FED. ROAD DIST. NO.	STATE	FED. AID PROJ. NO.	FISCAL YEAR	SHEET NO.	TOTAL SHEETS
HAWAII	HAW.	HSIP-056-1(53)	2010	ADD.3	18

9/13/10	 Amend General Note No. 6
	 Add General Note No. 17
DATE	REVISION
STATE OF HAWAII DEPARTMENT OF TRANSPORTATION HIGHWAYS DIVISION	
GENERAL NOTES AND LEGEND	
KUHIO HIGHWAY SAFETY IMPROVEMENTS	
Mile Post 2.98 to Mile Post 5.07	
Federal-Aid Project No. HSIP-056-1(53)	
Date: Sept. 2010	
SHEET No. 1 OF 1 SHEETS

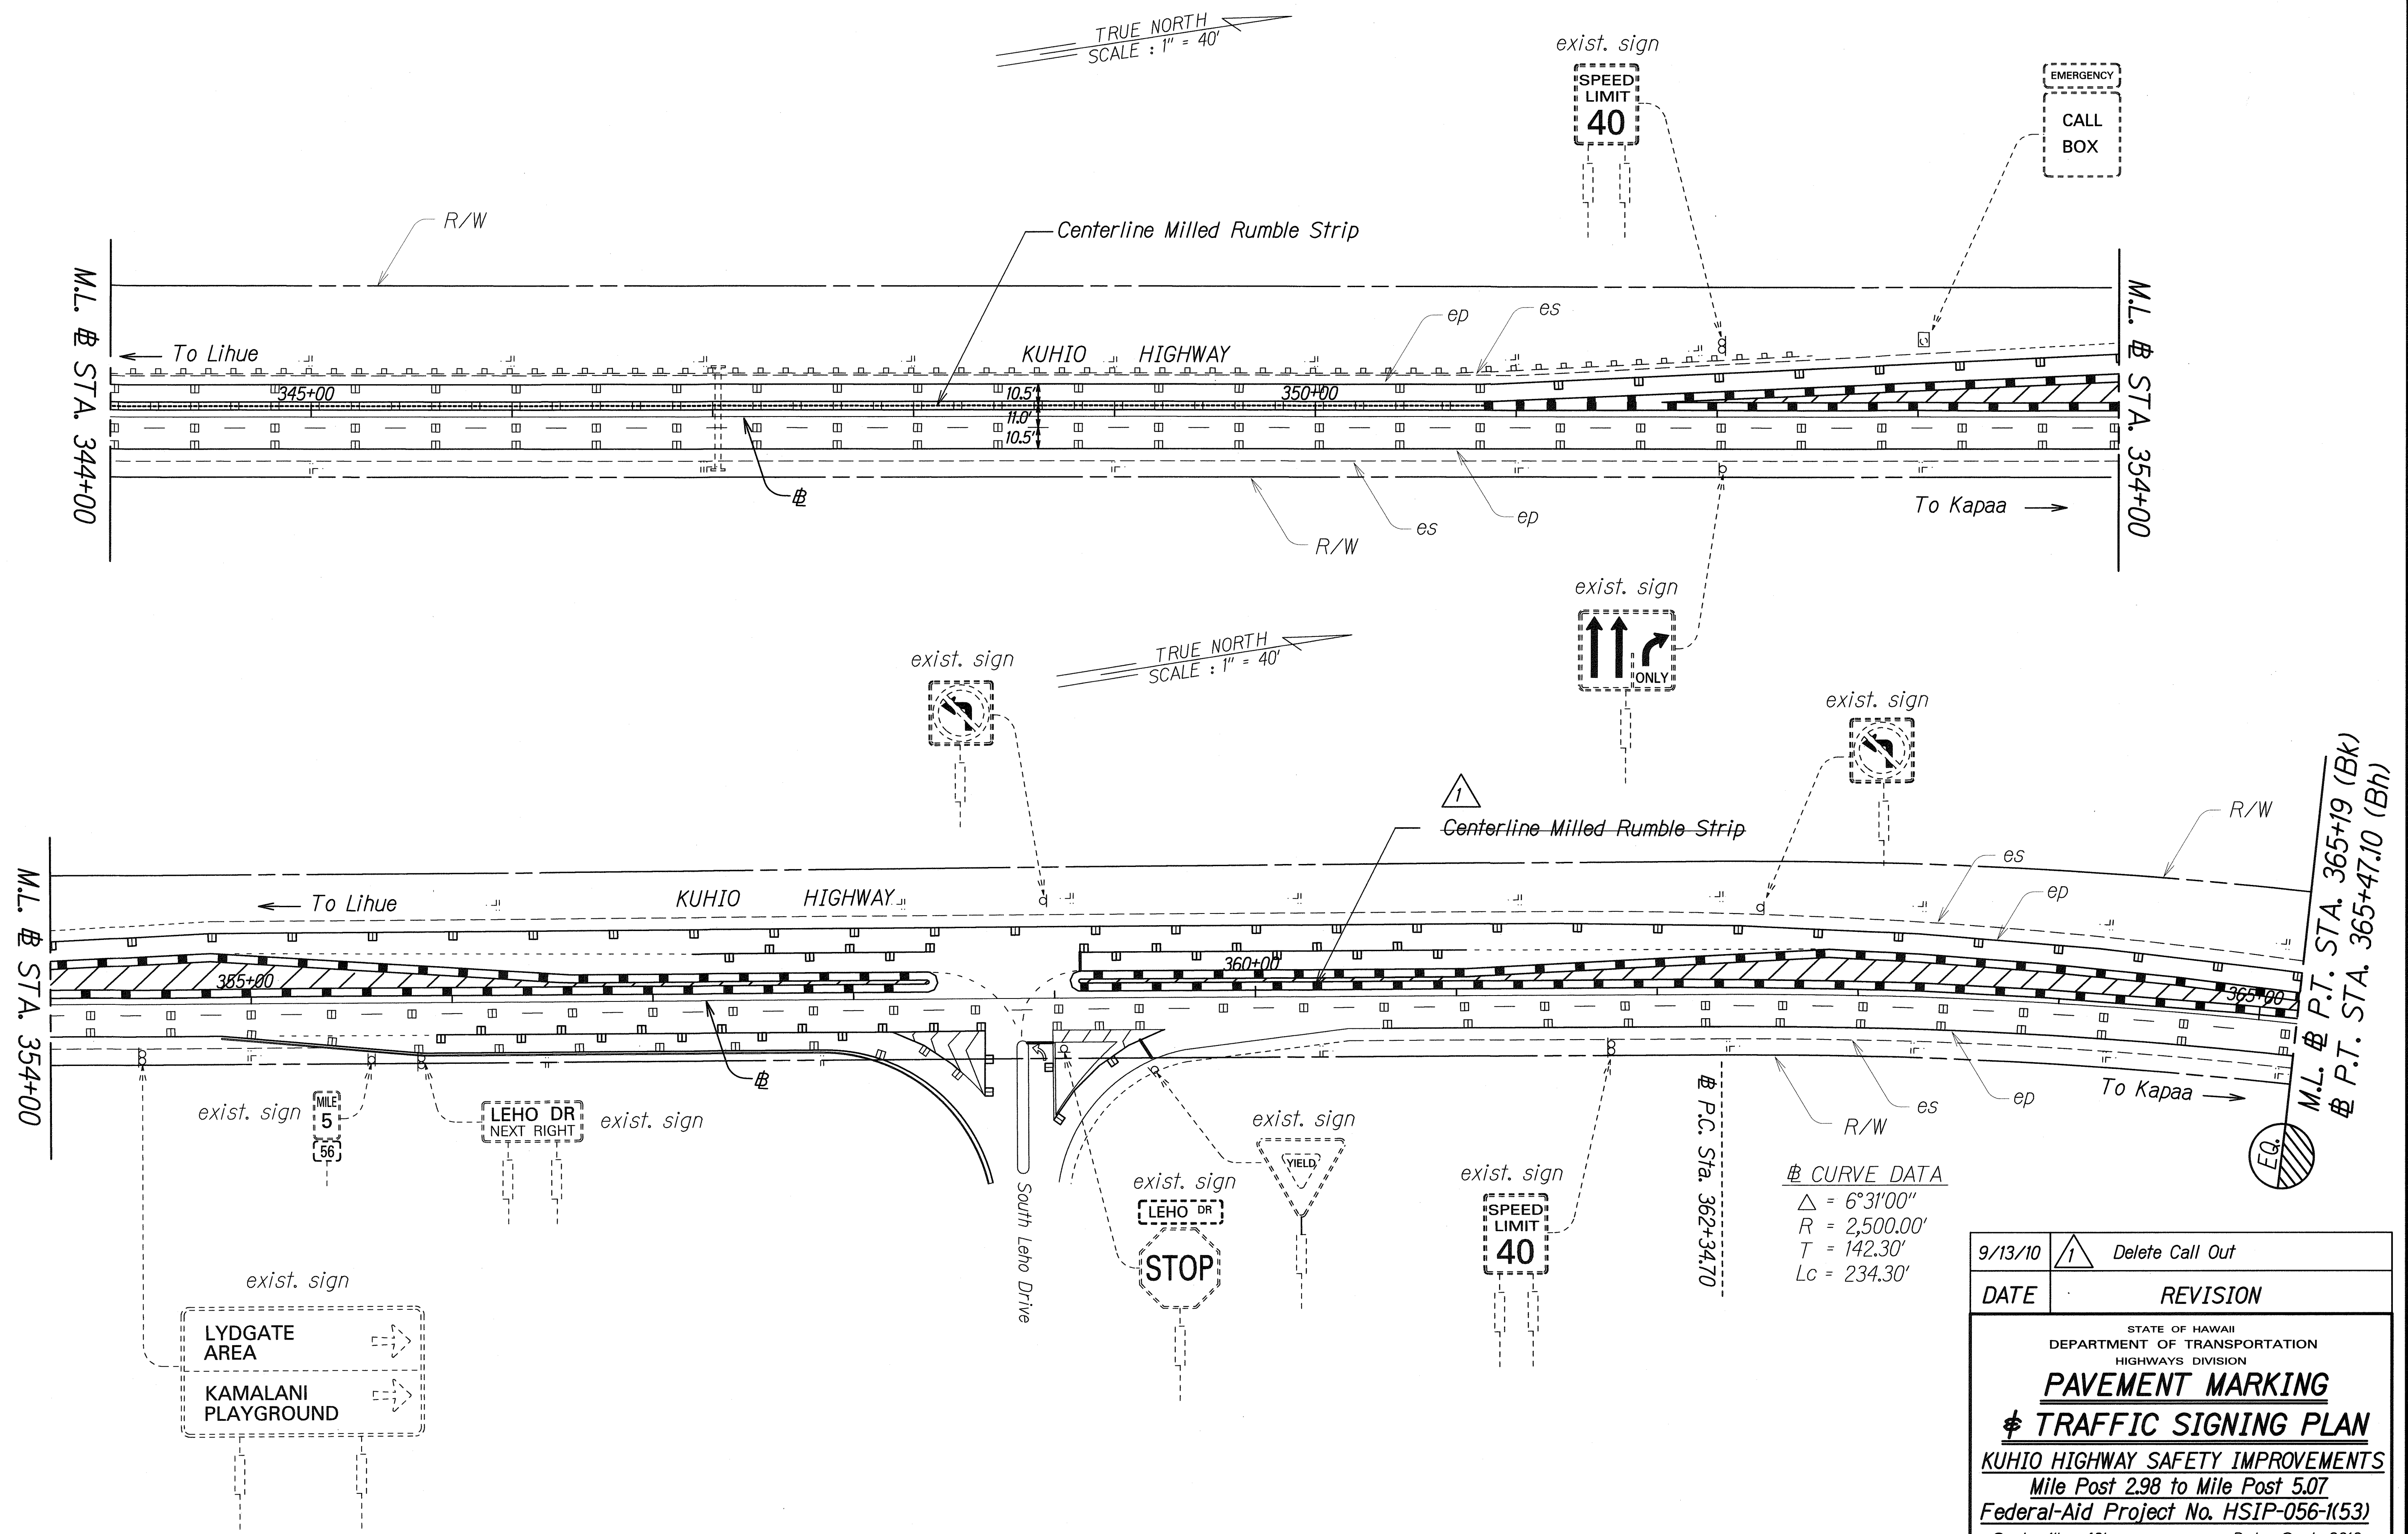
9/13/10	 Delete Call Out
DATE	REVISION
<p>STATE OF HAWAII DEPARTMENT OF TRANSPORTATION HIGHWAYS DIVISION</p> <p><u>PAVEMENT MARKING</u></p> <p><u>& TRAFFIC SIGNING PLAN</u></p> <p><u>KUHIO HIGHWAY SAFETY IMPROVEMENTS</u></p> <p><u>Mile Post 2.98 to Mile Post 5.07</u></p> <p><u>Federal-Aid Project No. HSIP-056-1(53)</u></p> <p>Scale: 1" = 40' Date: Sept. 2010</p> <p>SHEET No. 79 OF 12 SHEETS</p>
